ALPINE CITY PLANNING COMMISSION MEETING

SUBJECT: Proposed Amendment to section 3.9.5 Relating to Density in CE-5

To: Alpine City Planning Commission
From: Jed Muhlestein, P.E.
 Assistant City Engineer
Date: November 25, 2014
Subject: Staff Response - Proposed Amendment to the CE-5 Density Calculations

David's Court

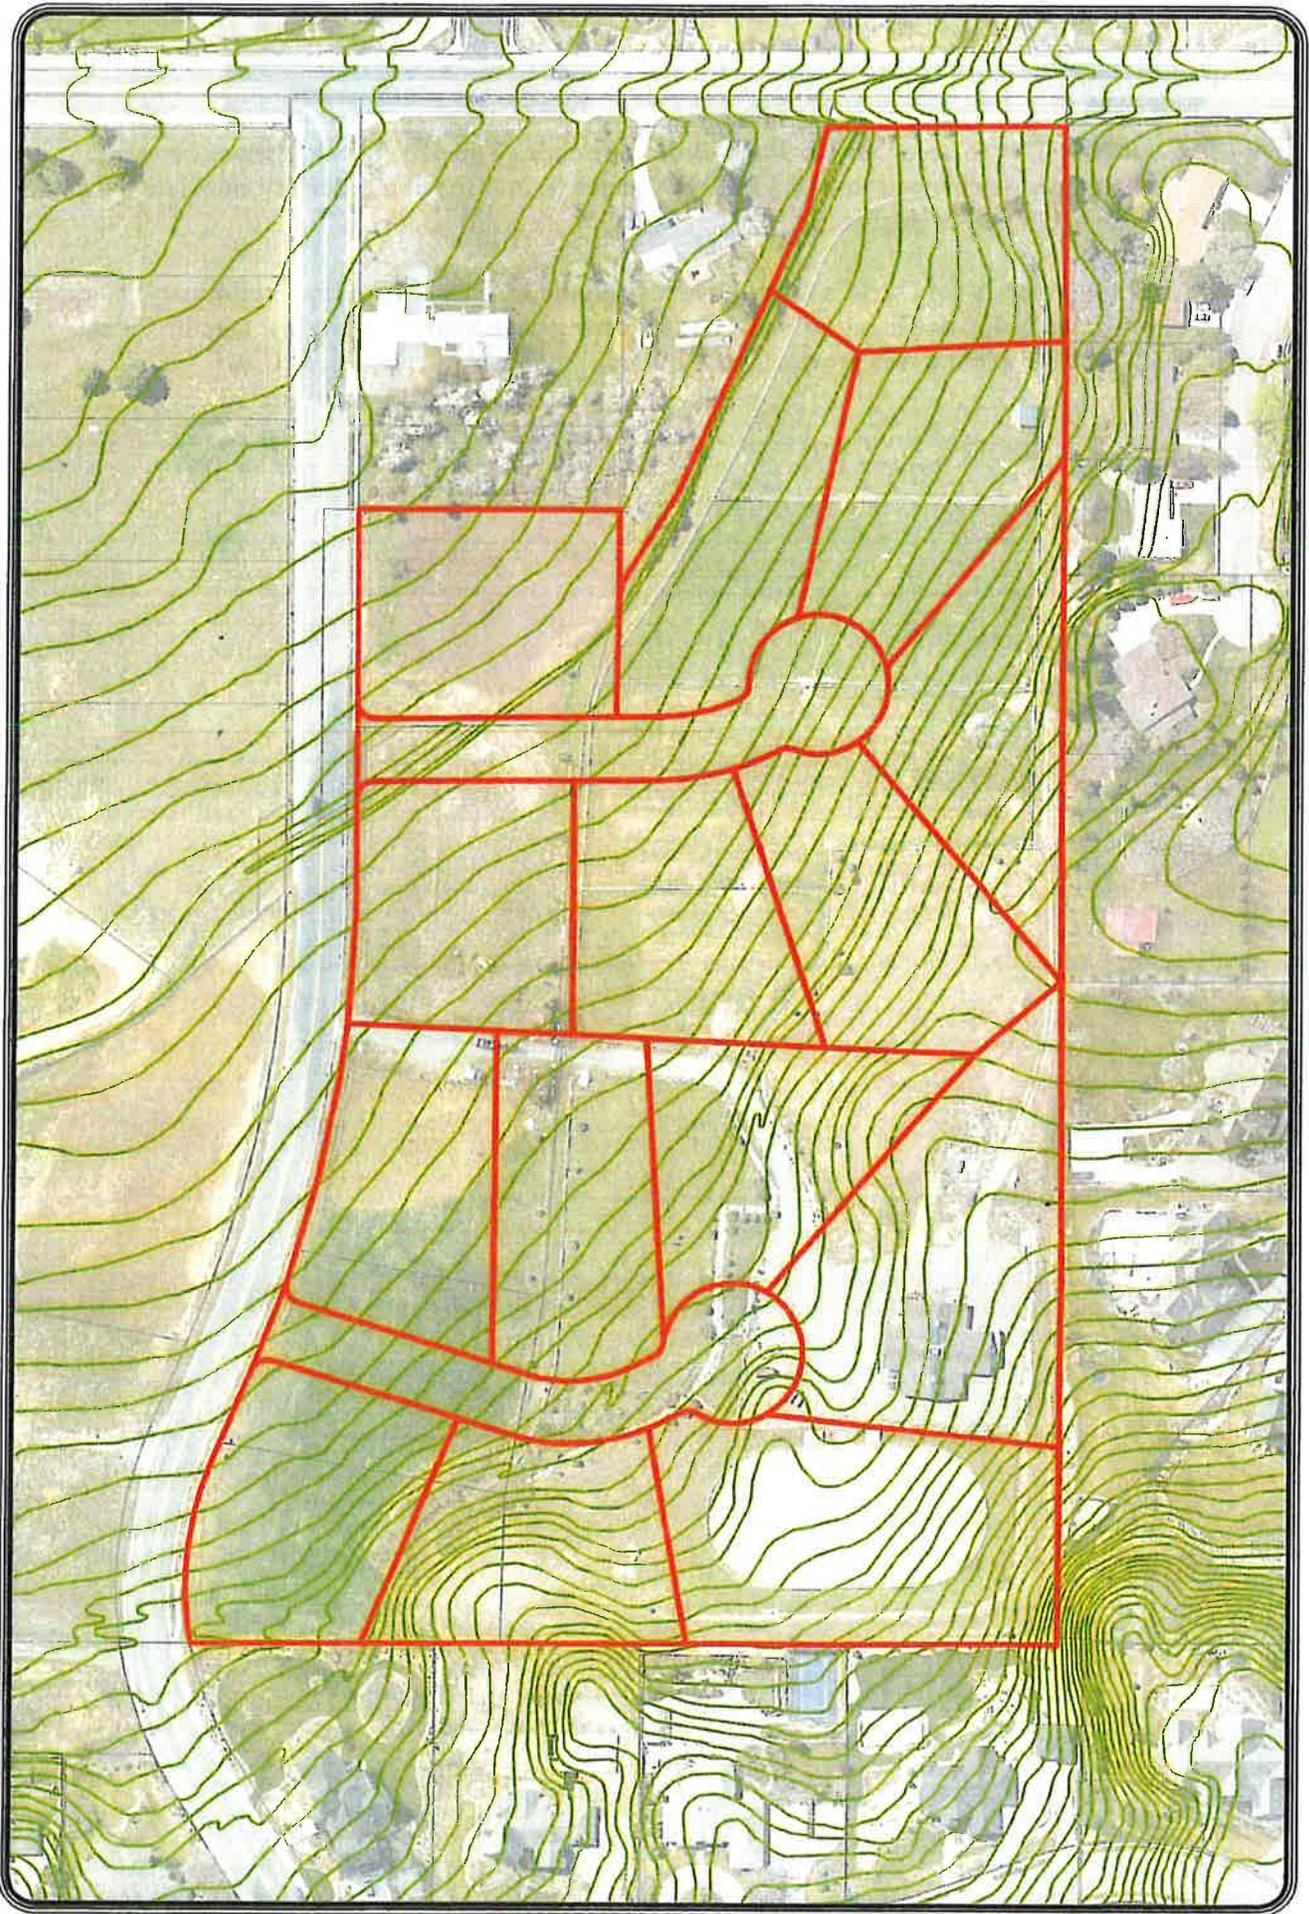
The engineer's for David's Court have revised their Concept Plan (for Preliminary) based on the proposed ordinance being passed. The following page is their revised lot layout. Please compare it to what was previously submitted.

Revised to meet proposed ordinance changes

Moyle Park Master Plan

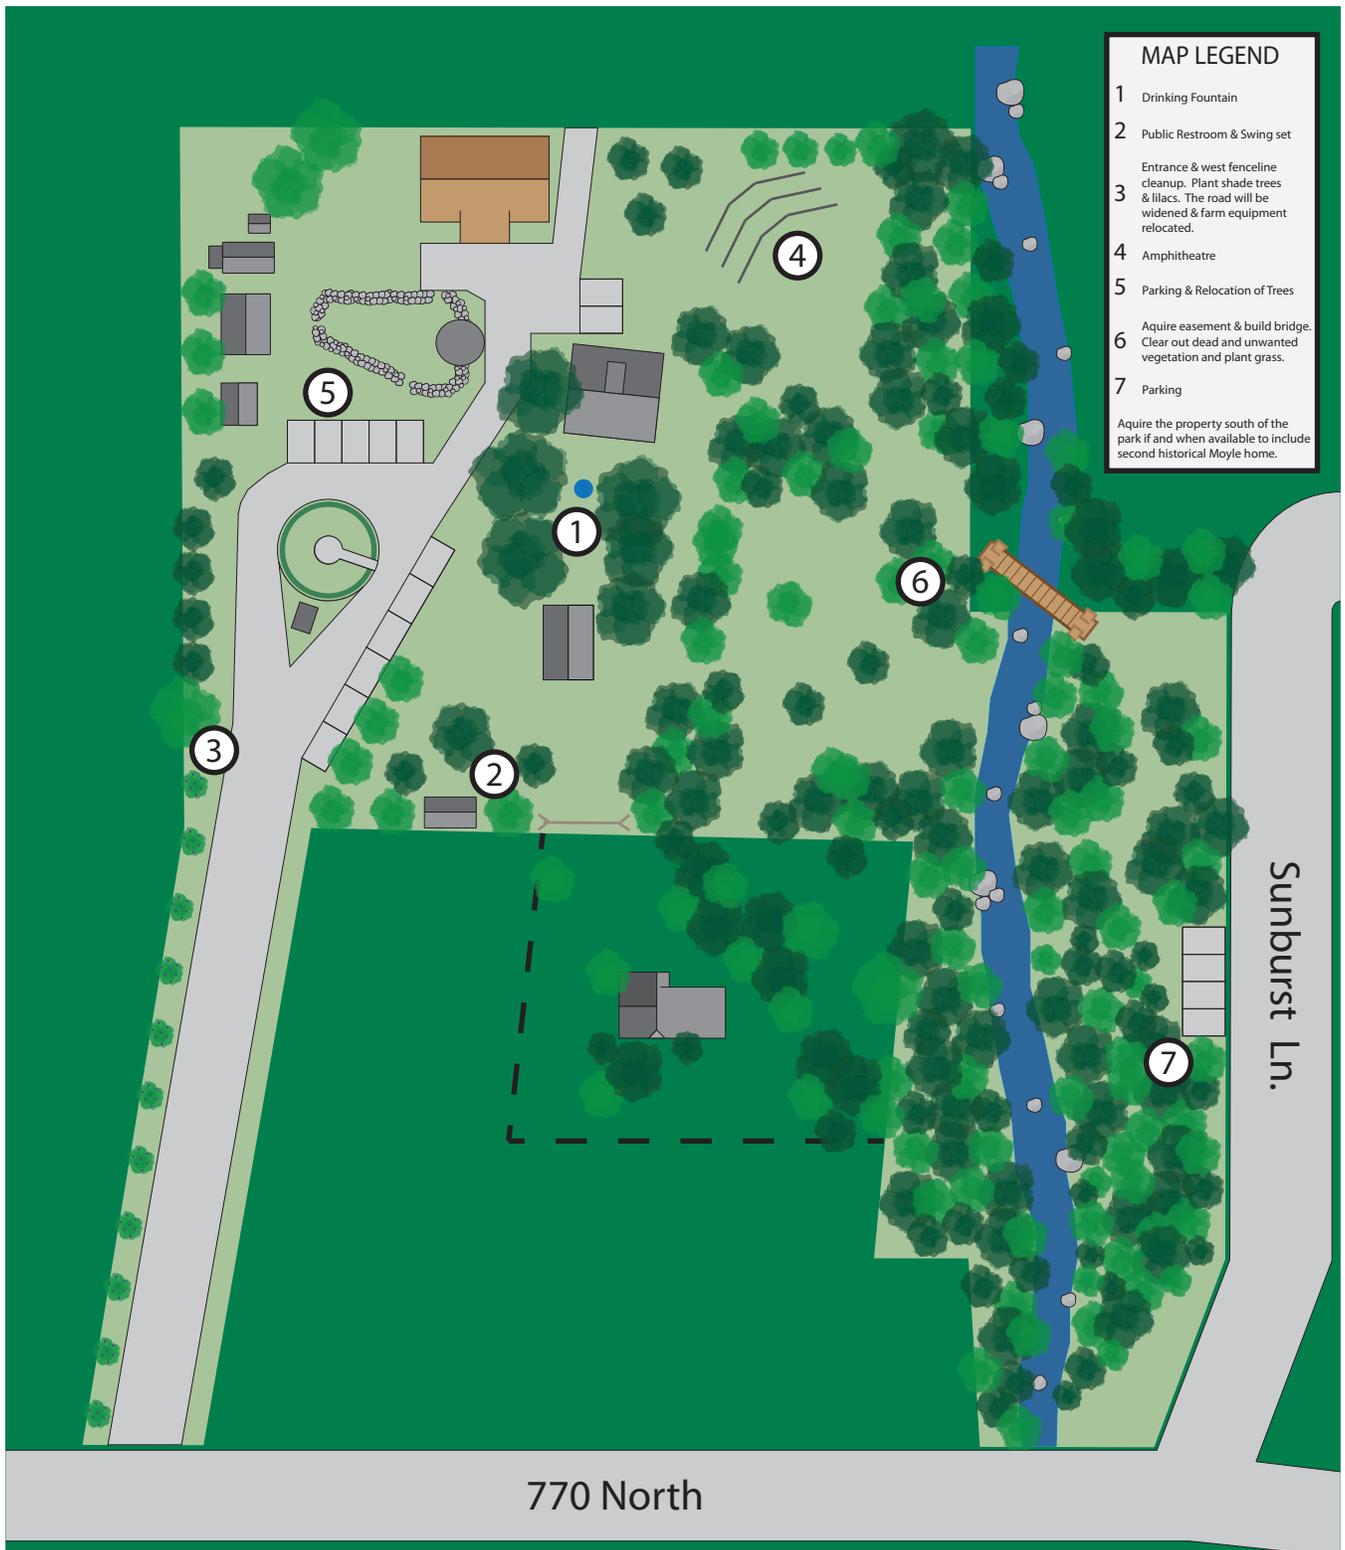
We recommend that the Moyle Park Master Plan be adopted with the following additions/changes.
